SVE BULLETIN

QVM BULLETIN: Q-274R2

2017 THROUGH 2019 F-SERIES SEPARATING STOP / TURN SIGNALS

REVISION	UPDATE	REVISION DATE
Q-274R2	Updated Bulletin with Model Year Cutoff Date	16SEP2020
Q-274R1	Added information on 2018 MY brake signal feed for added CHMSL.	23FEB2020
Q-274	INITIAL RELEASE	15JUN2017

Stop Signal Access:

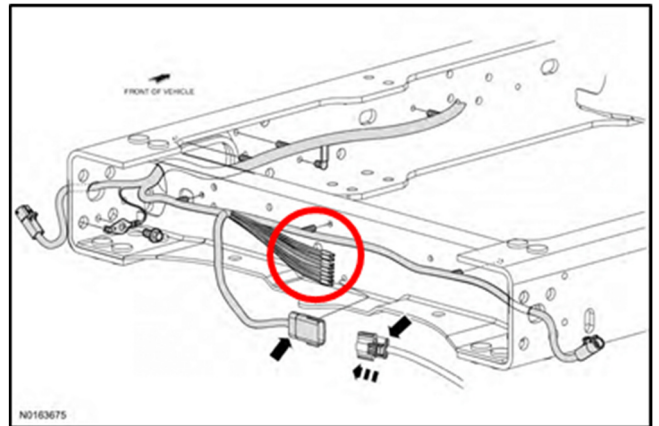
2018 Model Year and Later - A stop signal circuit is provided at the end of frame on the left hand (driver) side, in addition to the feed provided as part of the customer access circuits (located behind the passenger kick panel).

Wire Color	Circuit No.	Circuit Intent	Description
Violet	CBP04	High Mount Stop	6.7L Diesel, 6.2L / 6.8L Gas – BCM Pin C2280G-7 Intended for upfitter added CHMSL. BCM fuse F4, 5 Amp – Blunt cut taped to harness at rear of frame on left hand side

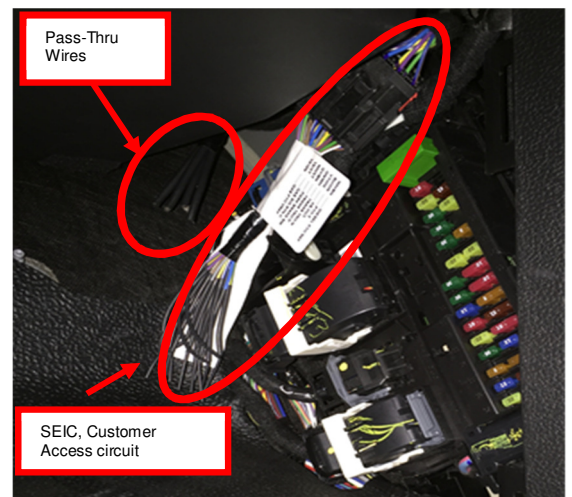
2017 Model Year - A stop signal is provided as part of the customer access circuits. The feed is located behind the passenger kick panel in the customer access pigtail only.

The service brake output signal is fused at 5 Amps and may be used to control a relay. This signal can be passed through the firewall using the pass-through circuits. The upfitter will need to run a circuit to the rear of the vehicle. A relay may be used

Conn. Pin #	Wire Color	Wire Tag	Circuit No.	Circuit Intent	Description
1	Violet	CBP04	CBP04	Service Brake signal output	6.7L Diesel, 6.2L / 6.8L Gas – BCM Pin C2280G-7 Intended for aftermarket Trailer Brake controller. BCM fuse F4, 5 Amp
